Relevant Information for Central Sydney Planning Committee

FILE: D/2023/97 **DATE:** 28 March 2024

SUBJECT: Information Relevant To Item 5 – Development Application: 12A and 14-26 Wattle Street, Pyrmont – D/2023/97

Figure 1: Tree retention value plan showing trees recommended for retention by the City's Tree Management Unit

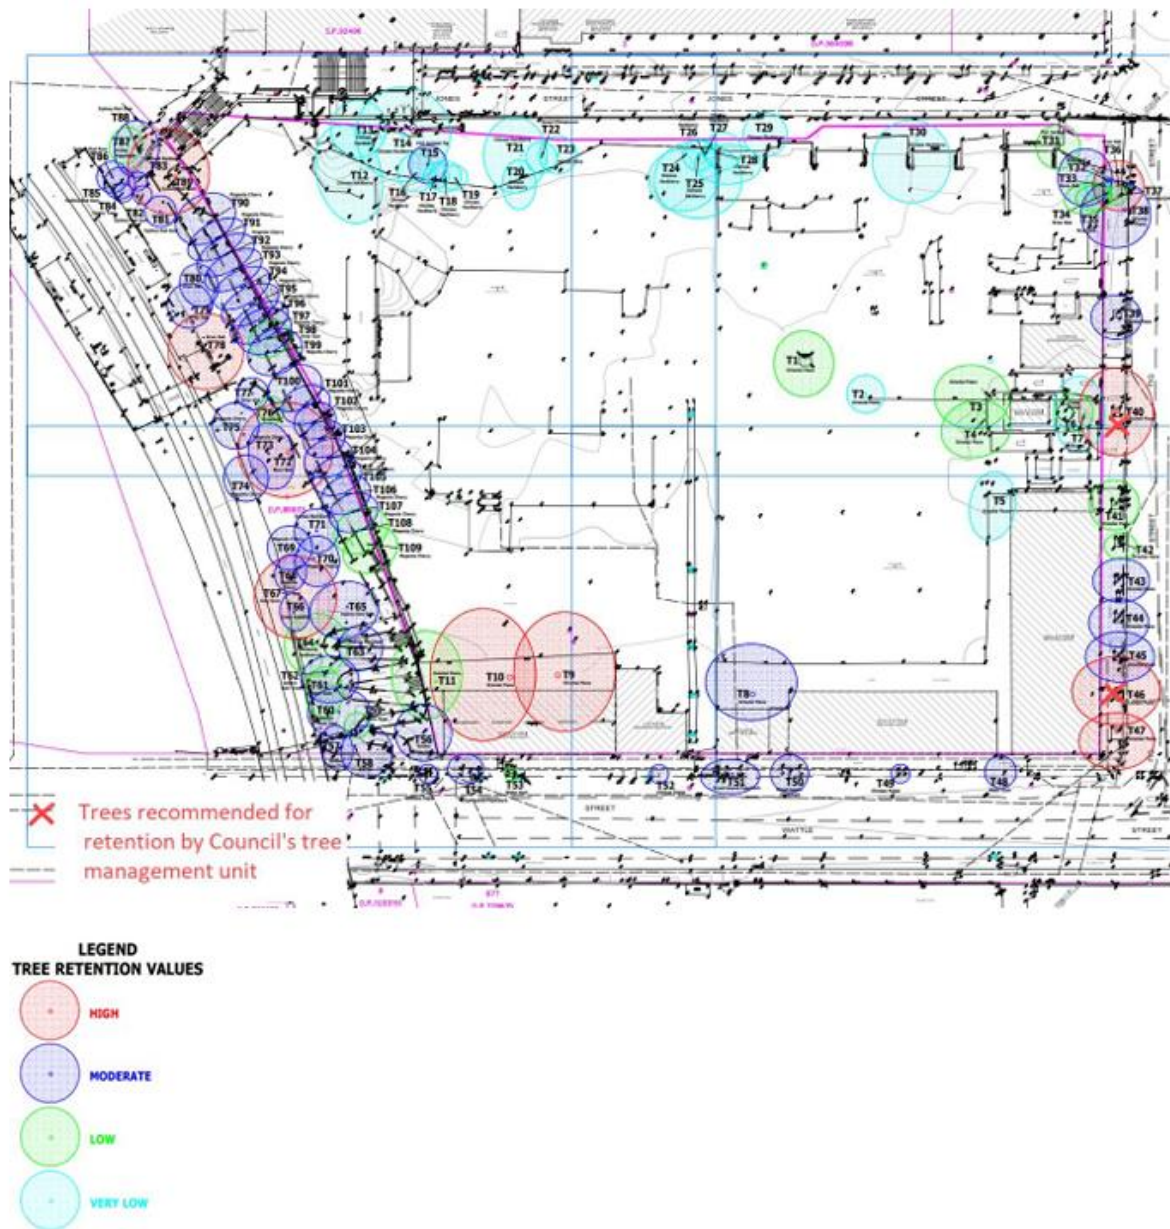
On 27 March 2024, correspondence was received from the applicant requesting that Tree 40, a *Platanus orientalis* Oriental Plane Street tree, on Fig Street, be approved for removal as the retention of this tree is an error (Conditions 44 – Trees Approved for Removal and 45 – Trees That Must Be Retained of Attachment B to the Central Sydney Planning Committee Report). The applicant has stated that Tree 40 is approved for removal in the concept development consent D/2019/649 (as amended).

Refer to Figure 1 below depicting the location Tree 40.

The City's Tree Management Unit advised during the assessment of the development application that Tree 40 is part of a group of street trees on Fig Street that are considered to be prominent landscape elements.

However, Condition 31 – Street Trees and Detailed Design Application of D/2019/649 (the Concept Approval) approved the Arboricultural Impact Assessment Report prepared by Earthscape Horticultural Services, dated 3 September 2019, which recommended the removal of Tree 40. Further to this, subsequent Arborist reports provided by the applicant for D/2023/97 support the original recommendation to remove Tree 40.

Should the Central Sydney Planning Committee be of a mind to support the amendment, Conditions 44, 45 and 141 are to be modified as follows:

~~(a) Retain Tree 40 (Oriental Plane Tree)~~

(b) Retain Tree 46 (London Plane tree).
